Access Compliance Report

Public Rights-of-Way

Intersection ID: 3210	Main Street: NOTTINGHILL_LN	Cross Street: CARVER_POND_RD	Location: SW
ADA ID: DB3402F9EA63	Ramp Type: PerpDiag	Initial Pass/Fail: Fail	Overall Compliance: No
		Severity Score: 42.5

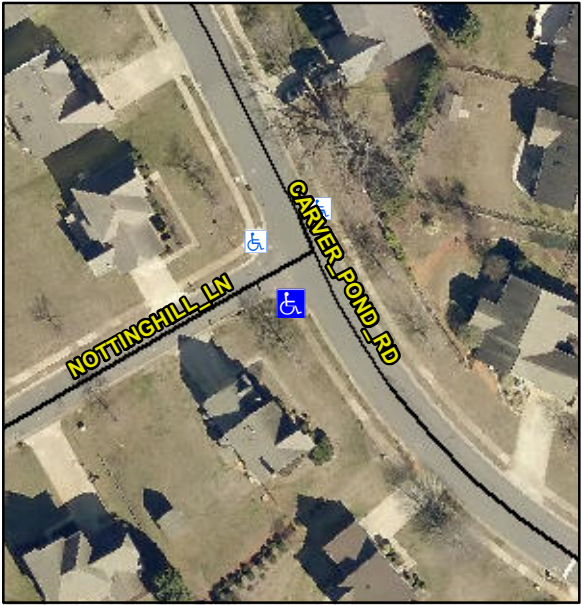
Codes/Mitigation Info/Possible Solution			Field Measurements/Component Compliance		
	Possible Solutions:		Compliance	Description	Data
	Remove & Replace Curb Ramp With Two New Directional Ramps or Equivalent.		N/A	Ramp Length (in)	96.0
			No	Ramp Width (in)	33.0
			N/A	Flare Type LT	N/A
			N/A	Flare Slope LT (%)	N/A
			N/A	Flare Traversable LT?	N/A
			N/A	Landing Length (in)	N/A
			N/A	Landing Width (in)	N/A
			N/A	Landing Slope (%)	N/A
			N/A	Landing X Slope (%)	N/A
<p>Surveyor Notes:</p> <p>N/A</p> <p>PROW/ADA:</p> <p>R304.5.1, R304.2.2</p>			N/A	Flare Type RT	N/A
			N/A	Flare Slope RT (%)	N/A
			N/A	Flare Traversable RT?	N/A
			N/A	DWS Provided?	N/A
			N/A	DWS Contrast?	N/A
			N/A	DWS Length (in)	N/A
			N/A	DWS Full Width?	N/A
			N/A	DWS Offset (in)	N/A
			N/A	Gutter Ponding?	N/A
			N/A	Gutter Lip Ht (in)	N/A
<p>Total Cost:</p> <p>\$ 3200.00</p>			No	Painted X Walk1?	No
				X Walk 1 Direction	To E
			N/A	X Walk 1 Width (in)	N/A
